CONTRACT CHANGE ORDER NO. _____
SHEET ____ OF ____

MARK	DATE	DESCRIPTIONS	BY	CH'D	CCO#
0	12/08/11	BARRIER COVER PL MODIFICATIONS	DT	HT	227

SAN FRANCISCO OAKLAND BAY BRIDGE
EAST SPAN SEISMIC SAFETY PROJECT
SELF-ANCHORED SUSPENSION BRIDGE
(SUPERSTRUCTURE & TOWER)

BARRIER DETAILS NO. 2G

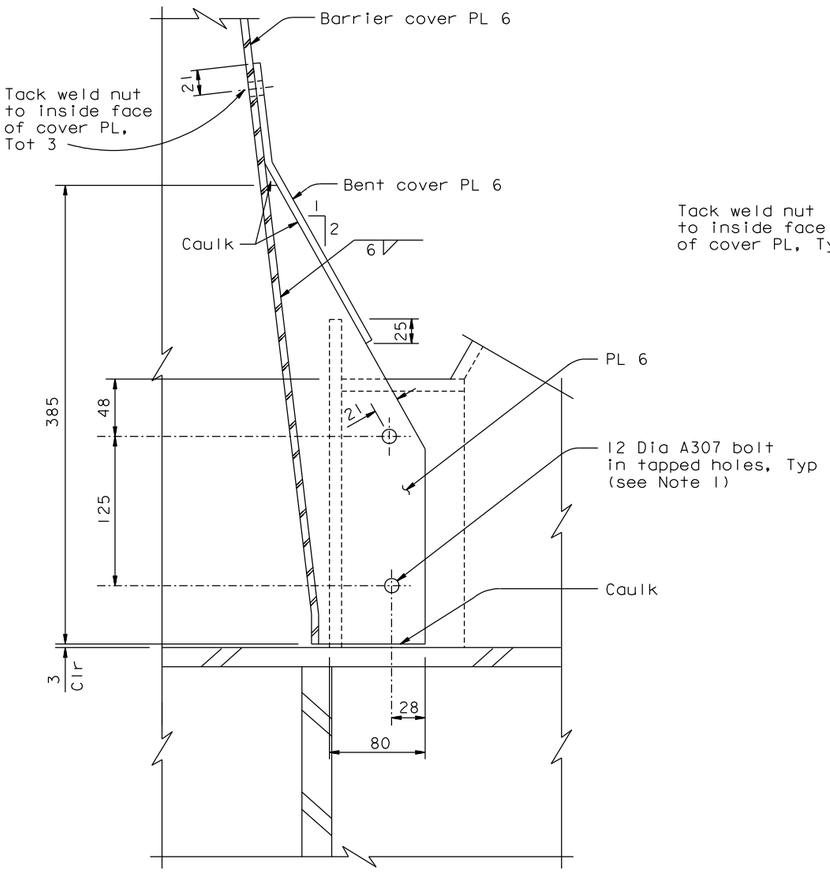
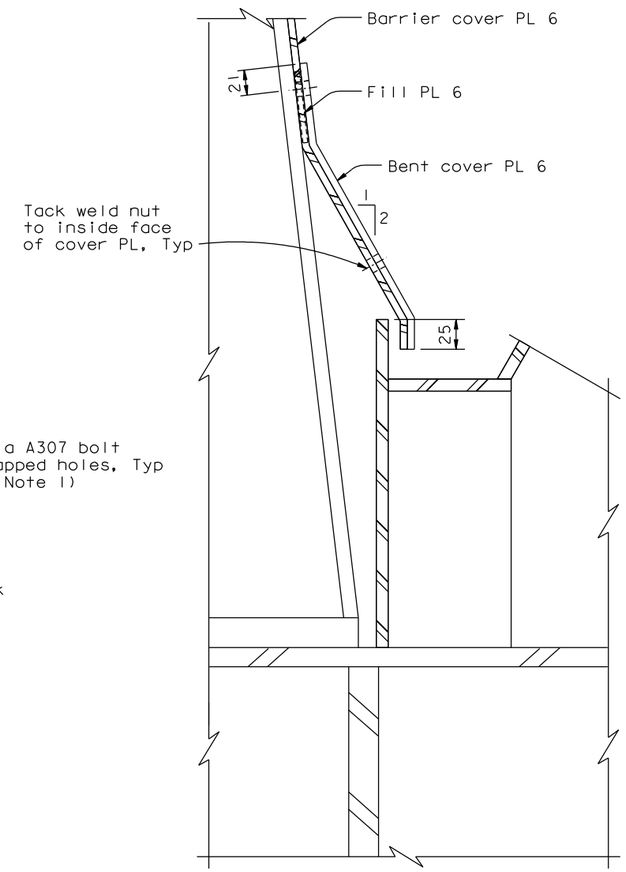
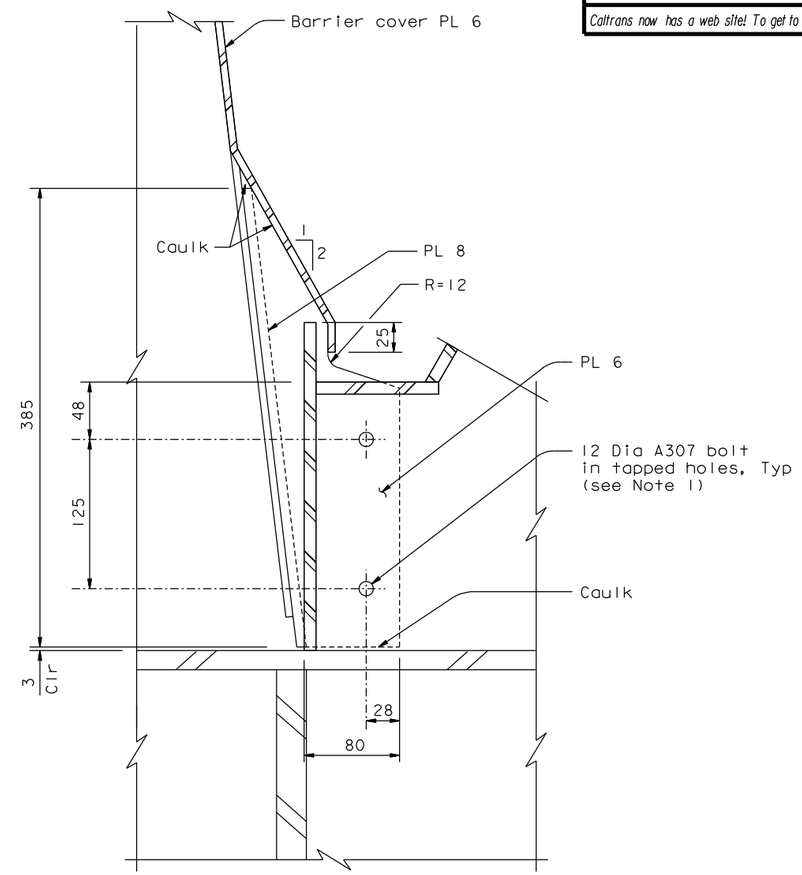
1. At the Contractor's option, 16 Dia oversize holes may be used in the cover plate with washer of sufficient size to cover the oversize holes, subject to review and approval of the Engineer.
